Subject: [FIXED] Beam pipe valves?

1) [viewer.gif](#), downloaded 556 times

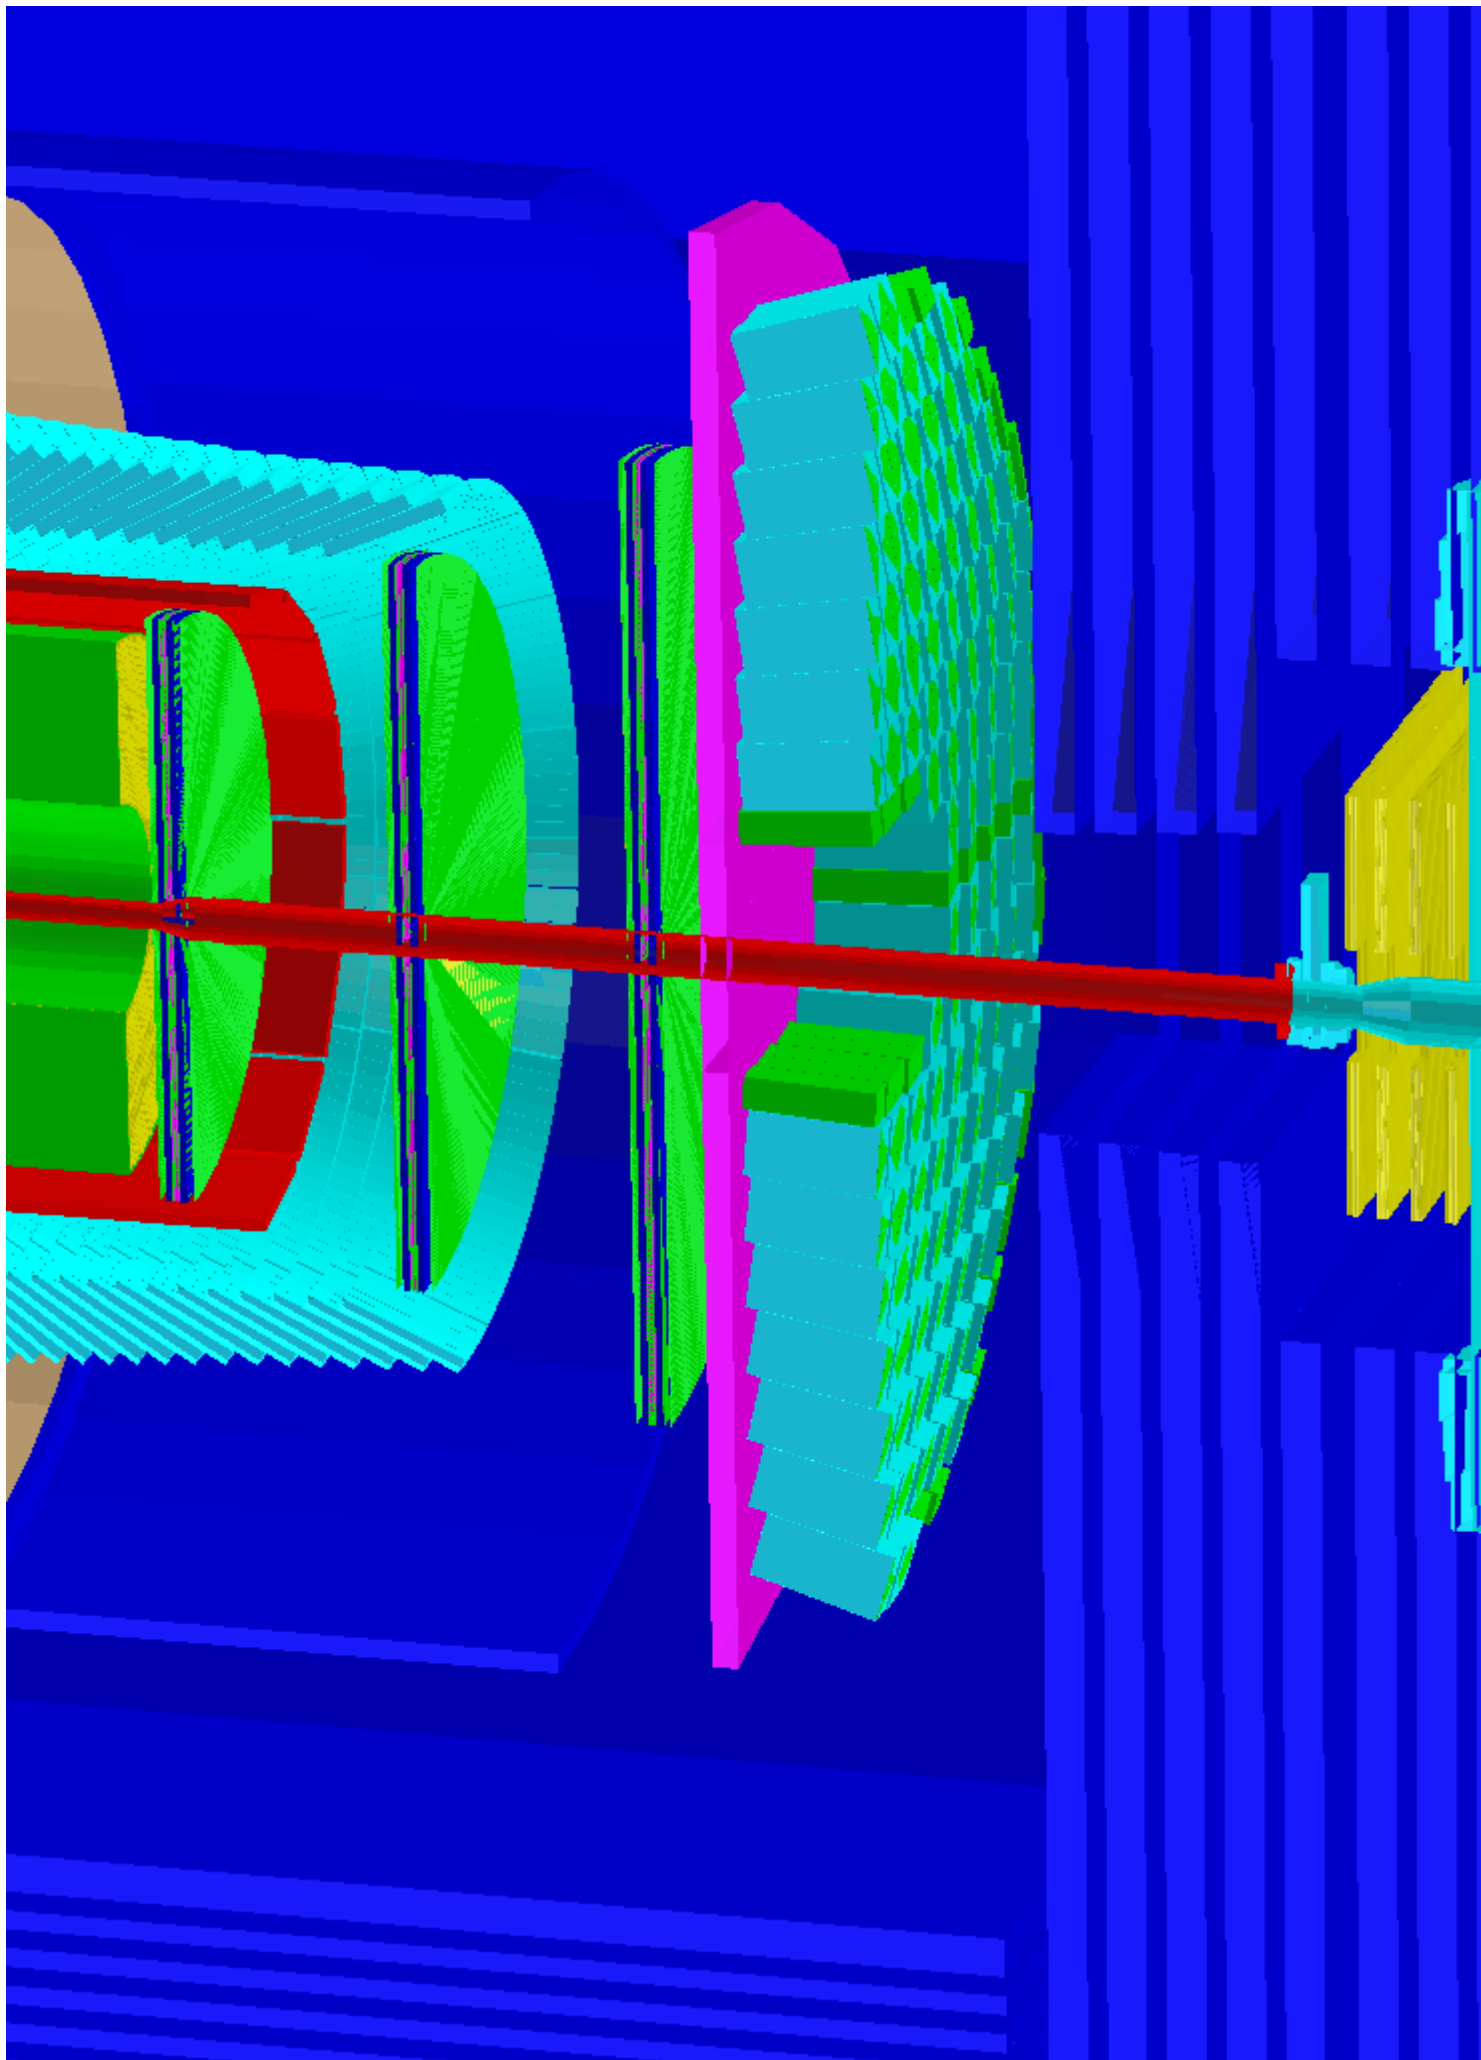
Dear all,
today I plotted the PANDA geometry and I have seen something strange:

In the OGL drawing you can see that the pipe has a sort of "tower" which is in the middle of the muon filter. I am wondering what is wrong there, if the "tower" should be really there, if maybe the muon filter should be modified to host it, or if maybe we have some geometry problems.

Indeed, this is the first pumping station downstream of the target. The description corresponds to what is to be found on EDMS since several years. So I guess that muon description is not up to date?

Fixed!

Please update your mdt folder, in particular those running analysis on forward tracker.
